SECTION 00911 - ADDENDUM 3

- A. Project Name: South Main Corridor Improvement Project
- B. Engineer: SK Design Group, Inc.
- C. Engineer's Project Number: 16-108.
- D. Date of Addendum: August 6, 2021

South Main Corridor Improvement Project (Phase 1)
STP-4300 (112)
City of Maryville, Missouri

C00.52

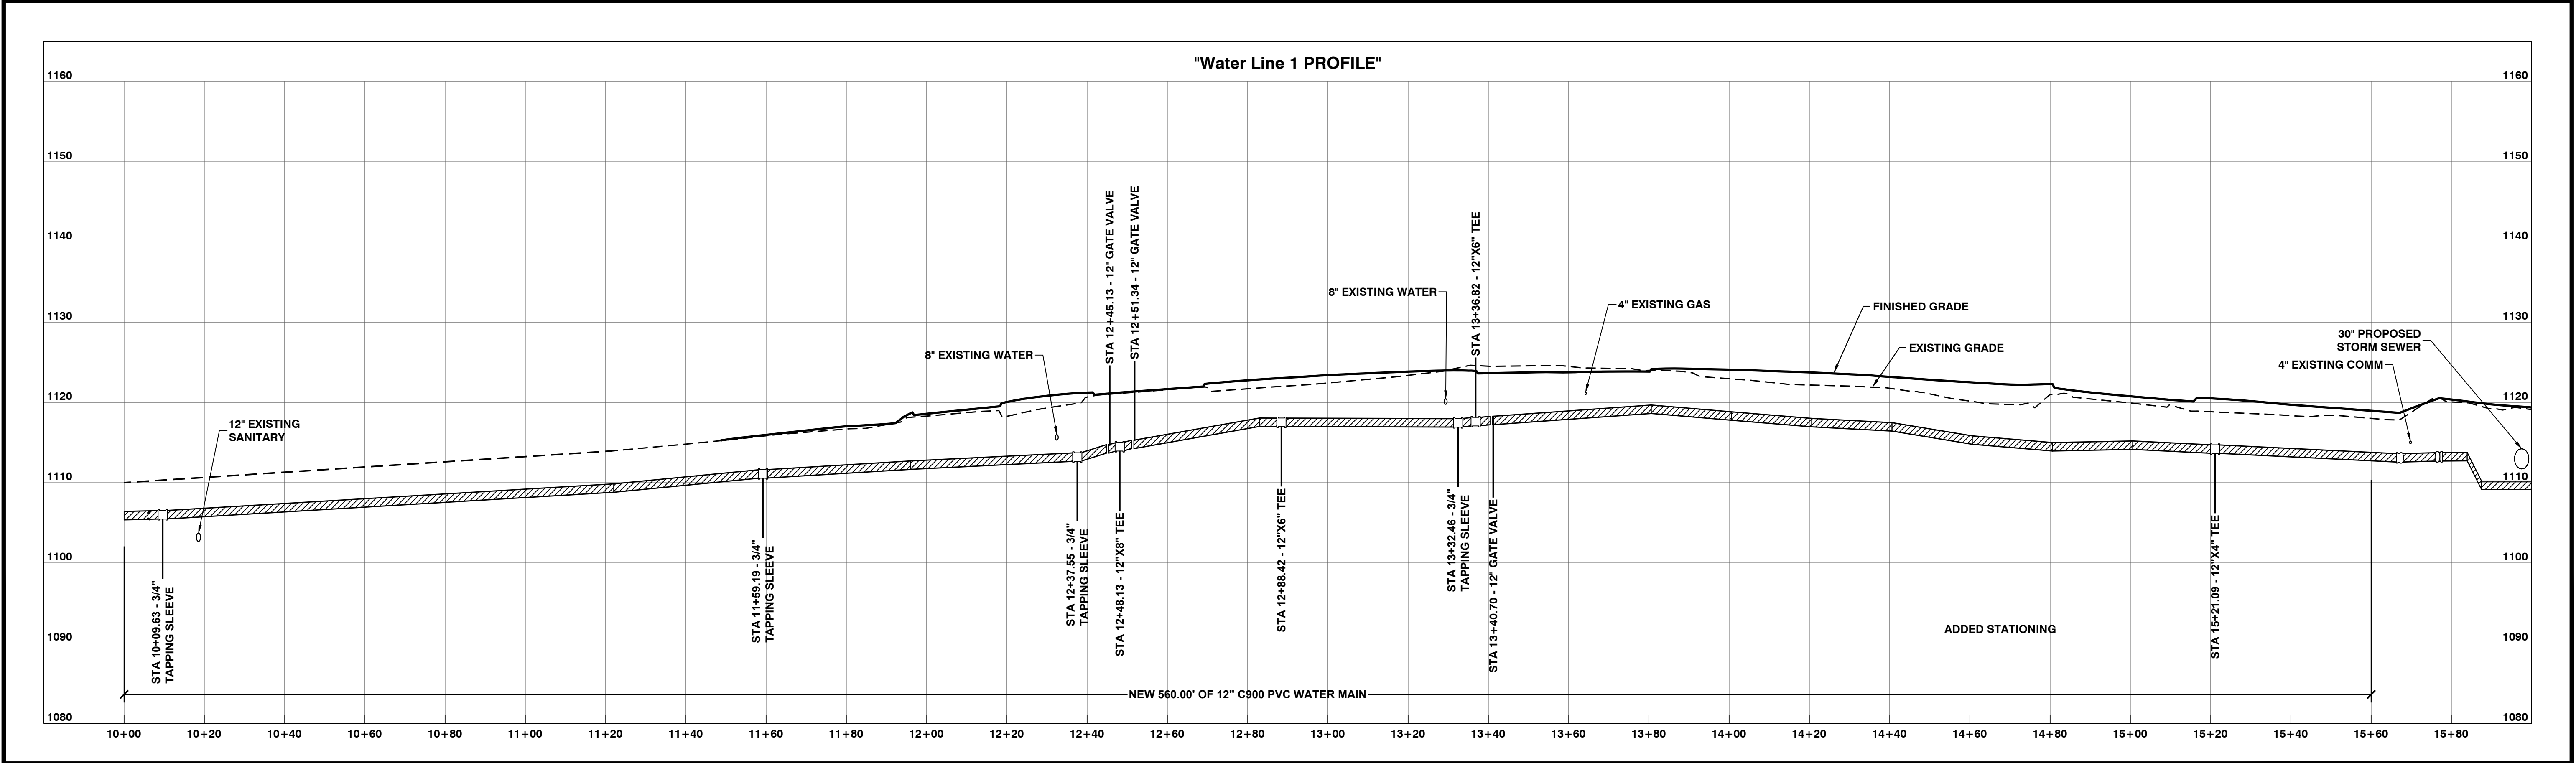
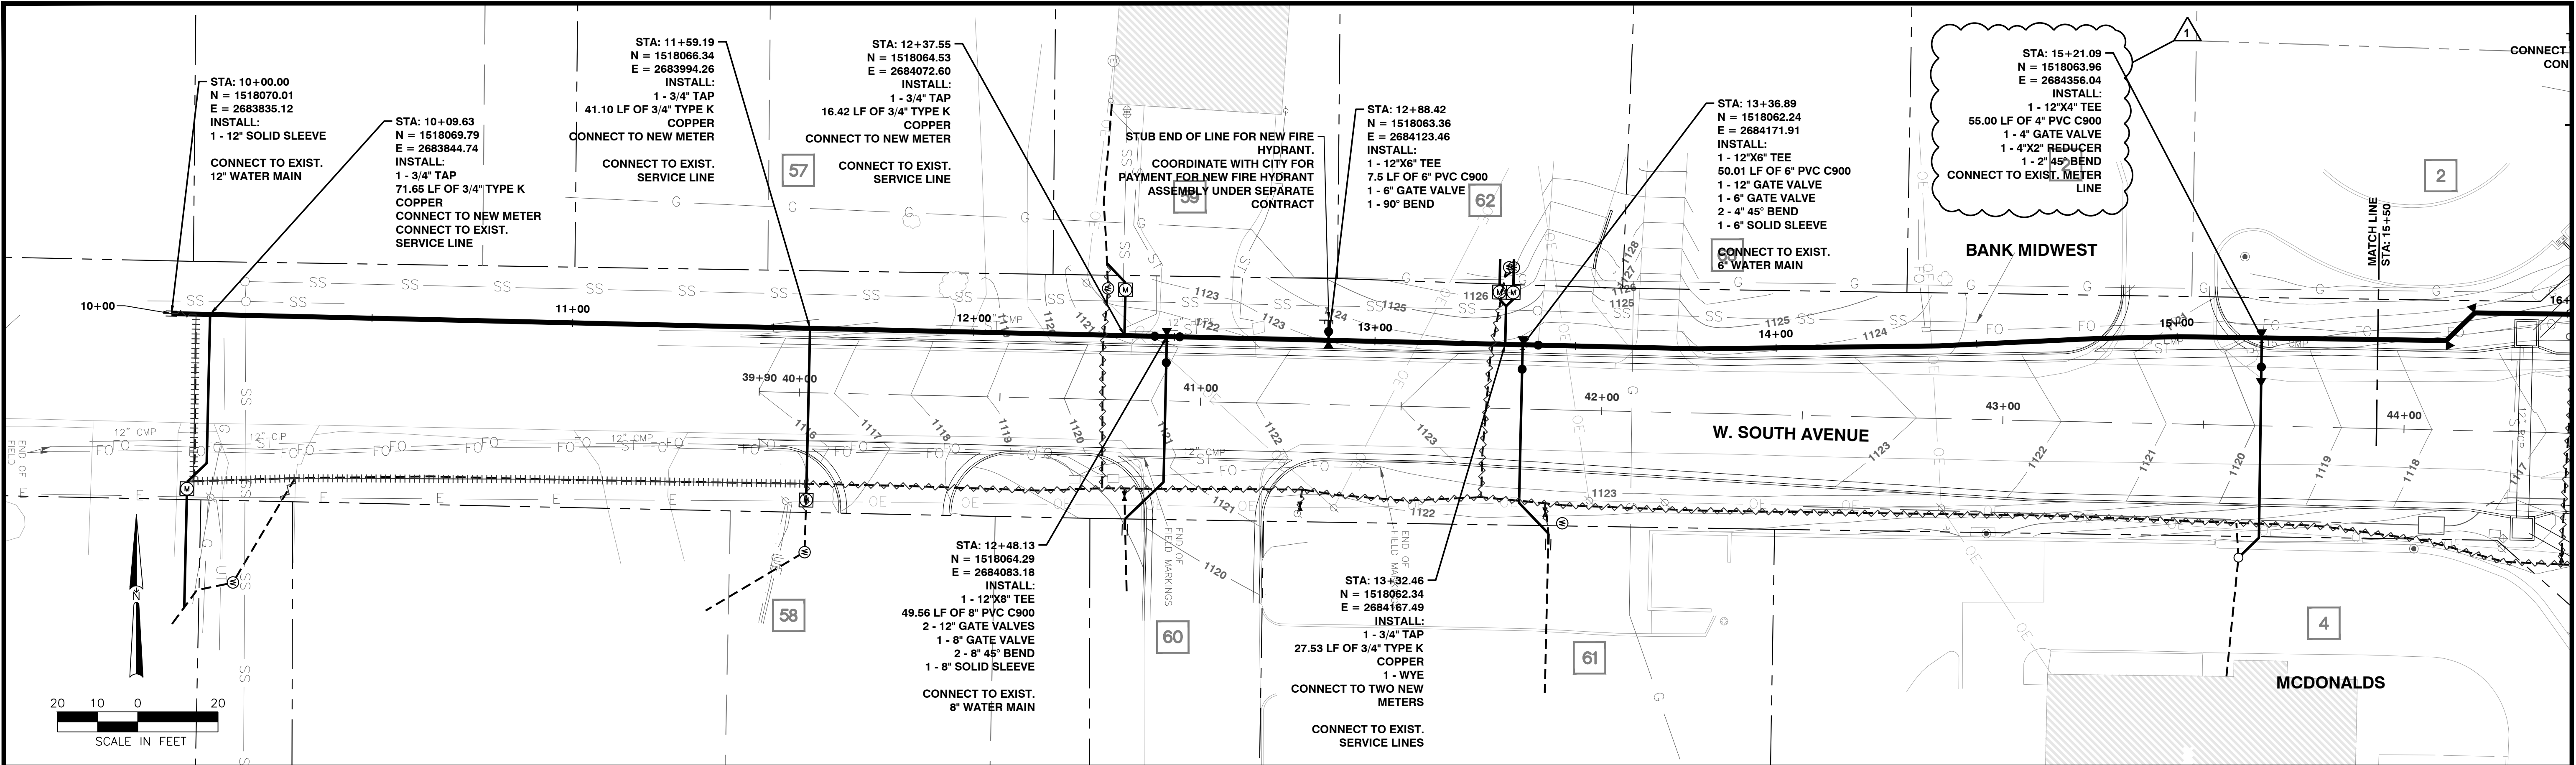
8. Pipe Quantities:
 - a. Question: Please confirm pipe quantities for 12 HDPE, slotted drain lines, 15" RCP, 15 CMP, 18" RCP and 18 CMP.
 - b. Answer: See revised unit price bid form.

- A. Delete the following drawing sheets in their entirety and replace with attached revised and clouded drawings, with the revision date of 08/06/2021.
 - 1. C00.52 Revised base bid quantities
 - 2. C09.01 Revised to clarify quantity for 4" PVC C900.
 - 3. C09.18 Added call-out notes for new water line connection to existing water line.
 - 4. C10.06 Revised location of underground marking tape of detail 9.
- B. SE001 Roadway Lighting General Notes
 - 1. Revised part numbers for RA1 and RA2 pole assembly to be aluminum poles.
 - 2. Clarified part number for mid-pole arm.
 - 3. Added equivalent manufacturer to type SH1 helix foundation.
 - 4. Added note regarding Buy America requirement.
- C. SE301 Roadway Lighting Details
 - 1. Revised description of pole to read “aluminum”.

1 ROADWAY LIGHTING POLE DETAIL - RA1 AND RA2

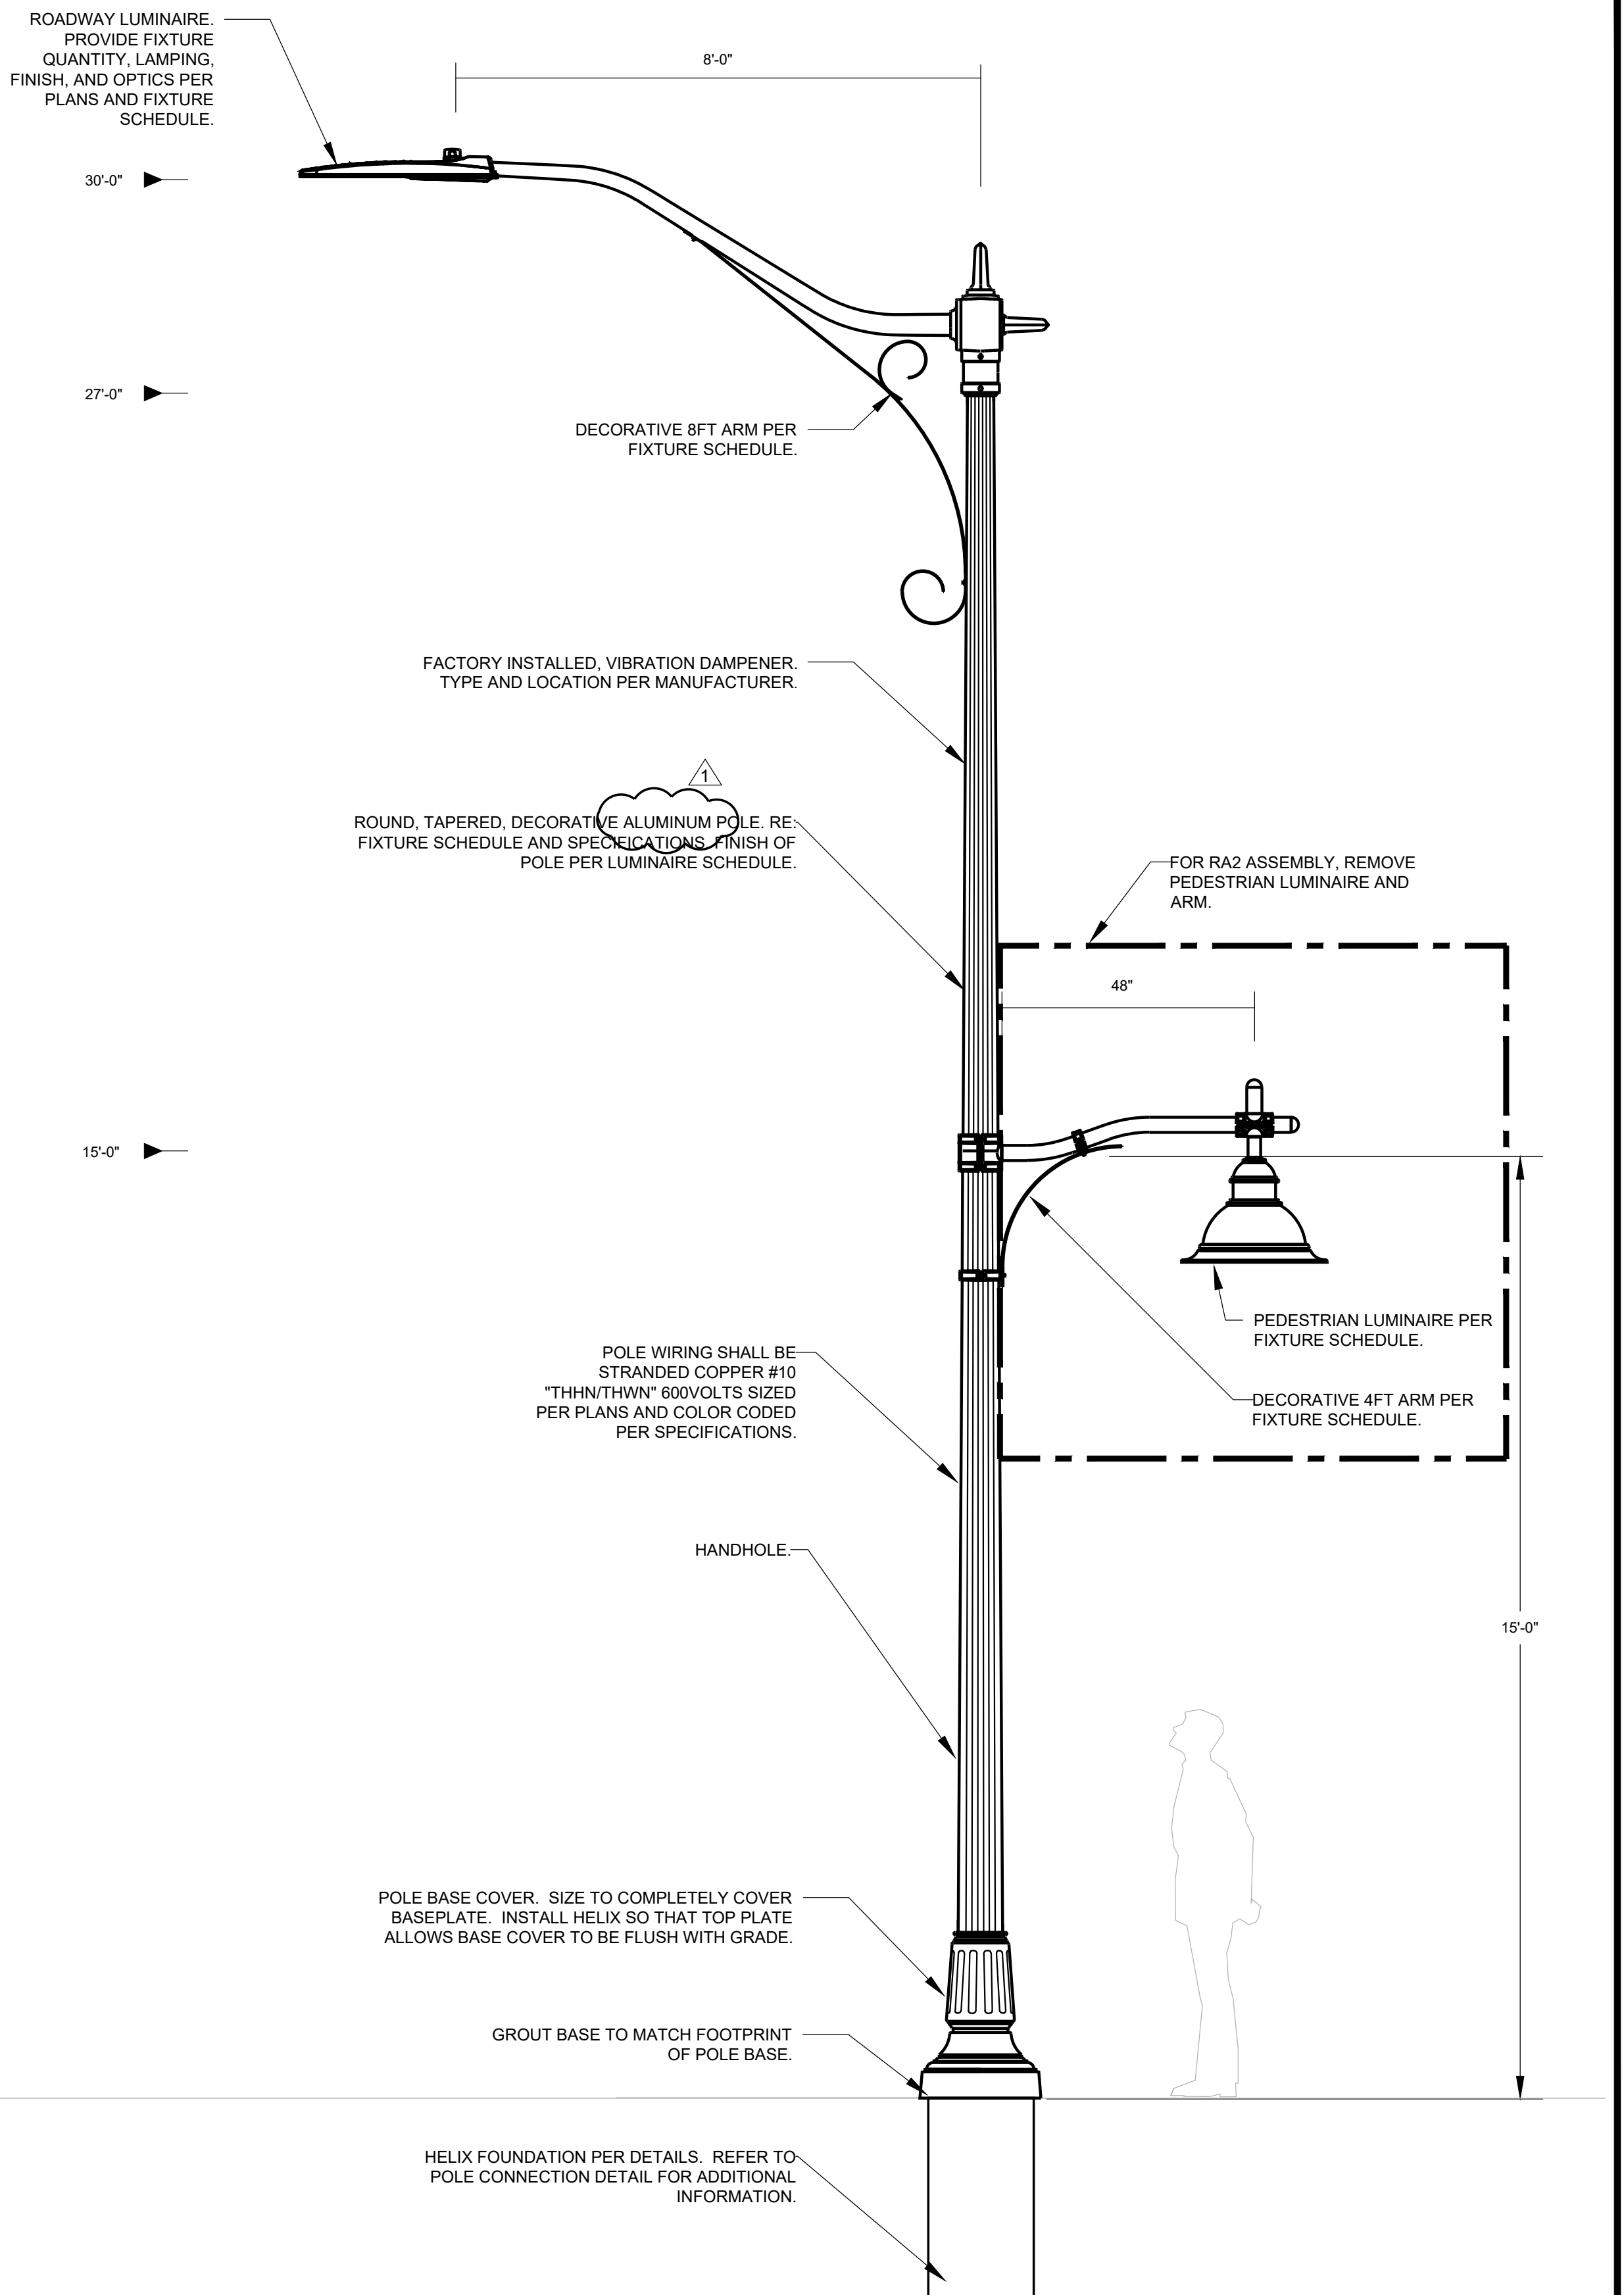
3. Street Lights and Signals
 - a. Question: Are all street lights and signals to meet Buy America requirements?
 - b. Answer: Sheets SE001 and SE301 Revised to include aluminum poles and note regarding "Buy America."
